Figure 6.2-2

CONSUMERS POWER COMPANY
BIG ROCK POINT ORGANIZATION

FORWARDING LIC NO DPR-6 APPL FOR AMEND: TECH SPEC PROPOSED CHANGE CONCERNING
PROPOSED ORGANIZATION CHANGES TO SUBJECT FACILITY STAFF... NOTARIZED
05/04/78... W/ATT.

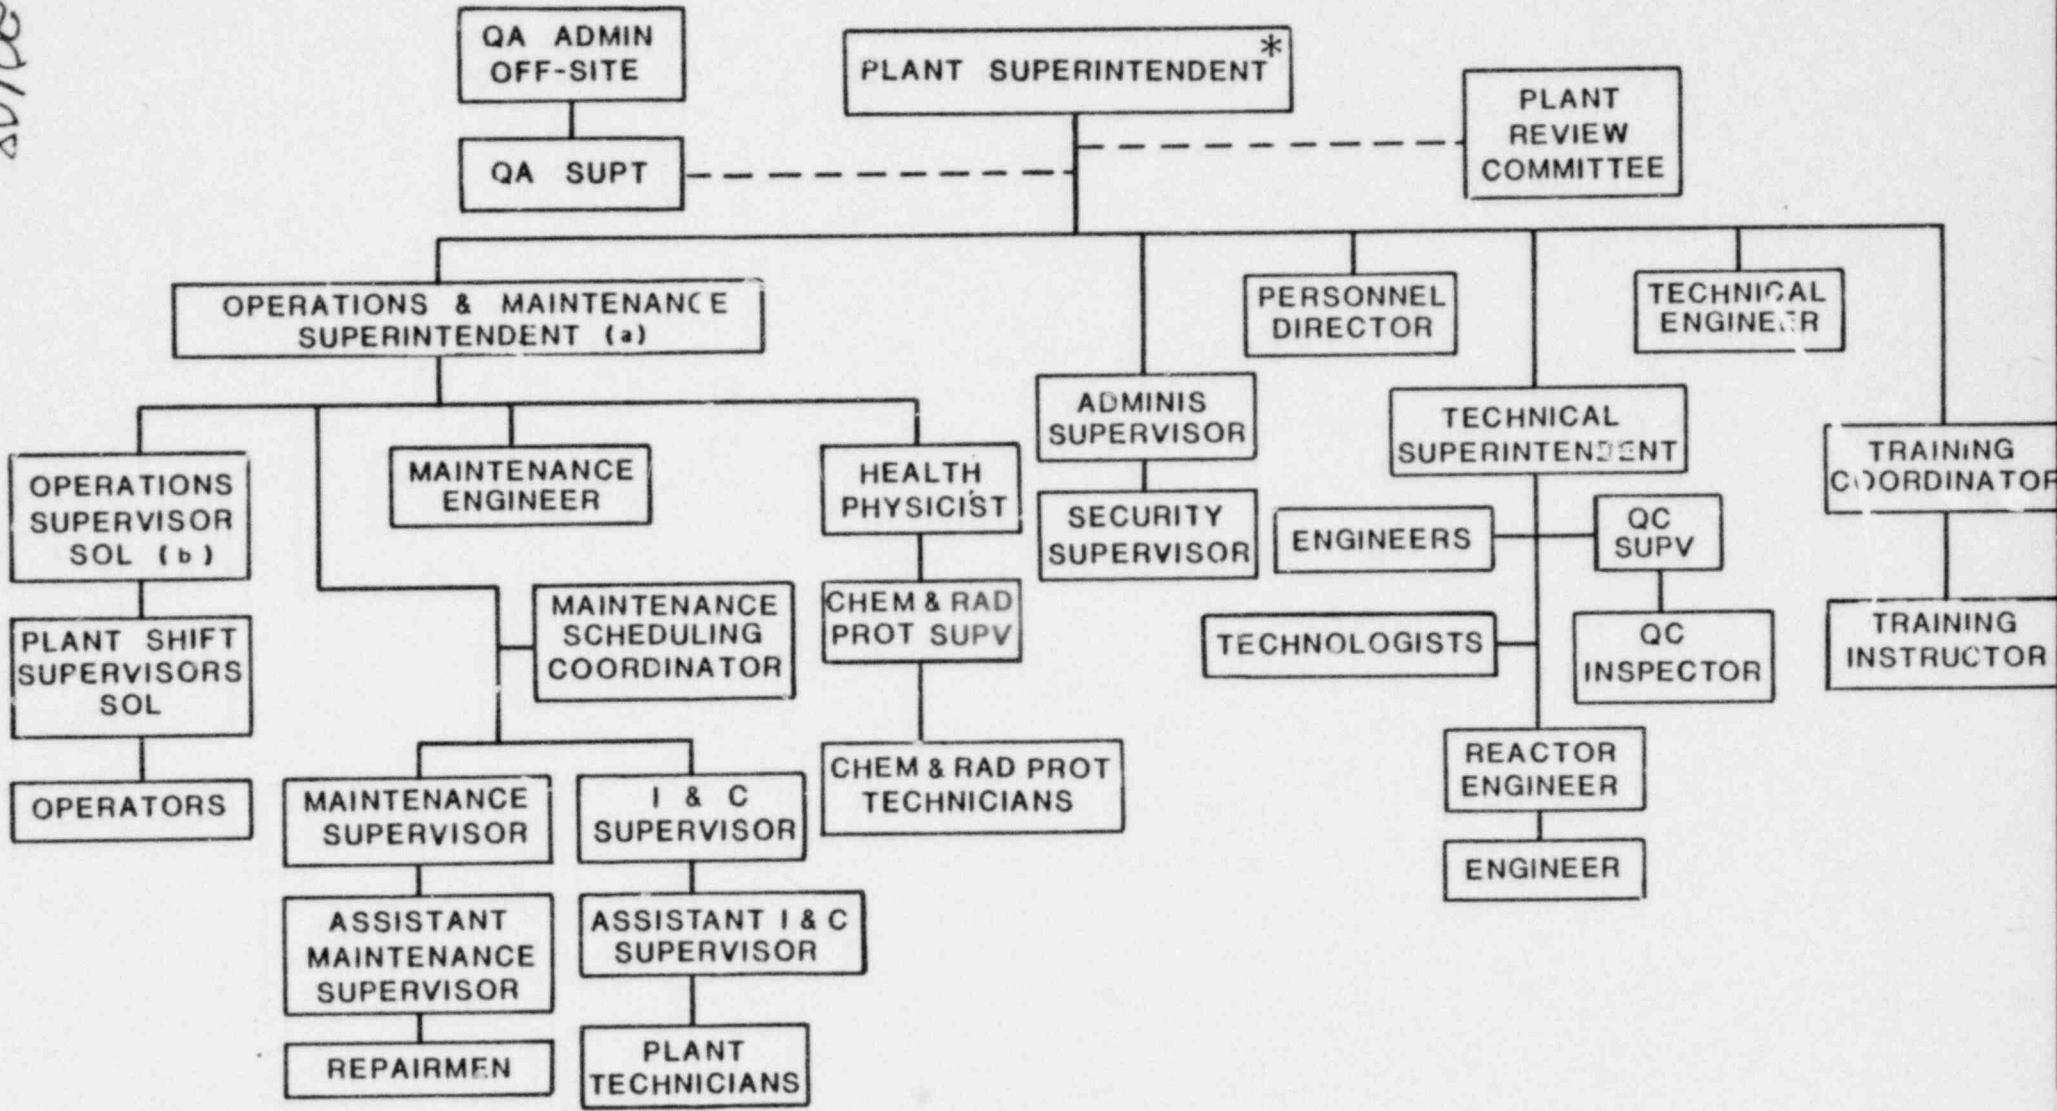
- (a) The Operations & Maintenance Superintendent need not hold an SOL provided he meets the other requirements of 6.3.1 of these specifications and the position of "Operations Supervisor" is filled. Under these conditions, the Operations Supervisor shall be responsible for directing the activities of licensed operators.
- (b) This position need not be filled if the Operations & Maintenance Superintendent holds an SOL.

*Responsible for overall implementation of the plant Fire Protection Program.
